RECEIPT DATE: 8/1/2017 **ONSITE SEWAGE DISPOSAL SYSTEM** P 561478

PROPERTY ADDRESS: 15064 Double Bridges

From: "Williams, Jeffrey" <jewilliams@howardcountymd.gov>
Date: Feb 6, 2017 1:55 PM
Subject: 15064 Double Bridges waiver
To: "michelle Mavronis (cmmavronis@gmail.com)" <cmmavronis@gmail.com>
Cc:

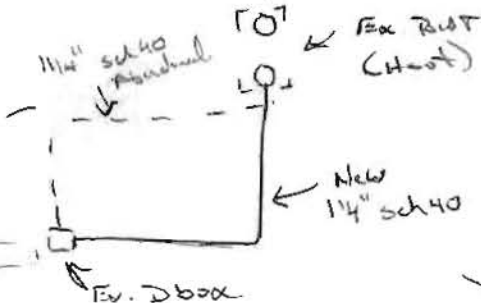
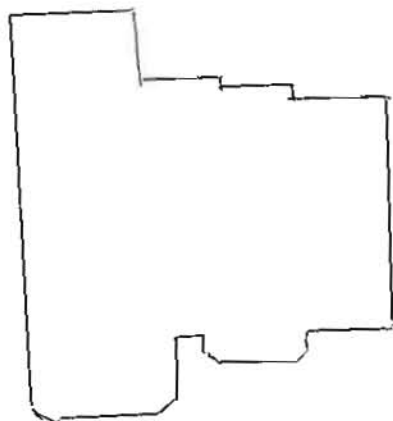
LOCATION:	Indicated in field
NOTES:	Re-route existing 4" pvc sch 40 line from septic tank to distribution box to avoid new pool installation.

INSTALLATION: 8/11/17 New 1 1/4" sch 40 pressure pipe re-routed.
 Pump test verified. FAT 'OK' OK to cover all work.

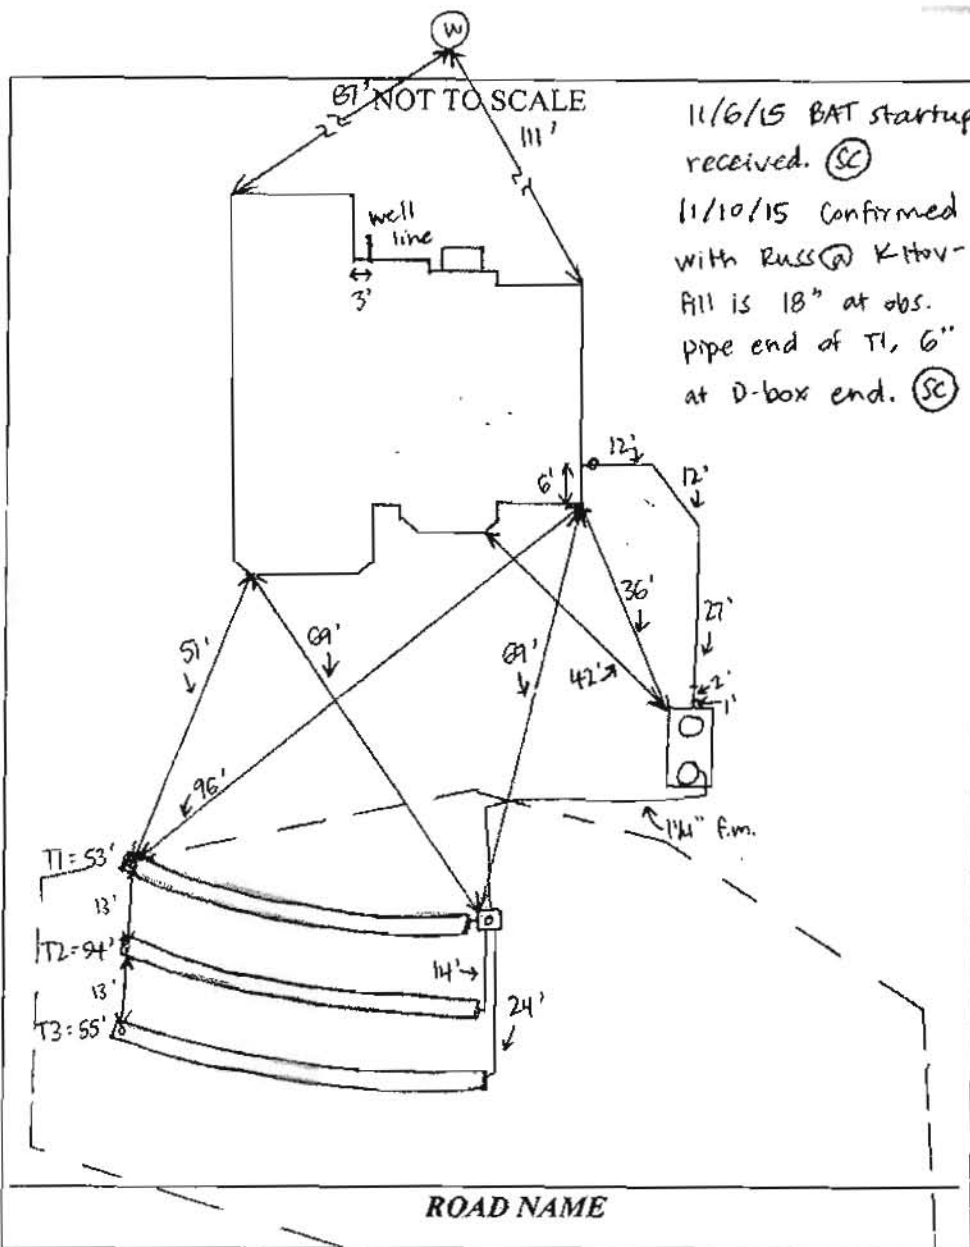
1. The location of the hot tub appears to be in conflict with the location of the sewer line running from the house to the treatment tank. The building permit plot plan must show the location of that line. If the line interferes with the hot tub location, the line must be relocated prior to Health approval of the building permit. In order to relocate the line, a plot plan must be submitted showing the proposed location of the line along with elevations of the invert at the house foundation and at the tank inlet. The contractor must obtain a sewer house connection permit from our office (\$165) prior to performing the relocation work. If the line does not interfere with the hot tub location, show the present location of the line on the plot plan.

2. Similarly, the line running from the tank to the distribution box appears to be in conflict with the pool location. That line location must also be shown on the plot plan and if it must be relocated, the same procedure as described above must take place. If both lines need to be relocated, they can both be done under the same permit.

3. The plan appears to show an outdoor kitchen. If there is a sink associated with the plan, the plot plan must show the location of the sink waste line. It must either travel back into the house to connect to the interior plumbing, in which case it will be reviewed and inspected by the plumbing department, or it must connect to the sewer line upstream of the treatment tank, in which case it will require a sewer house connection septic permit from our office and the proposed location of the line must be shown on the building permit plot plan for our review as the septic permit plan.
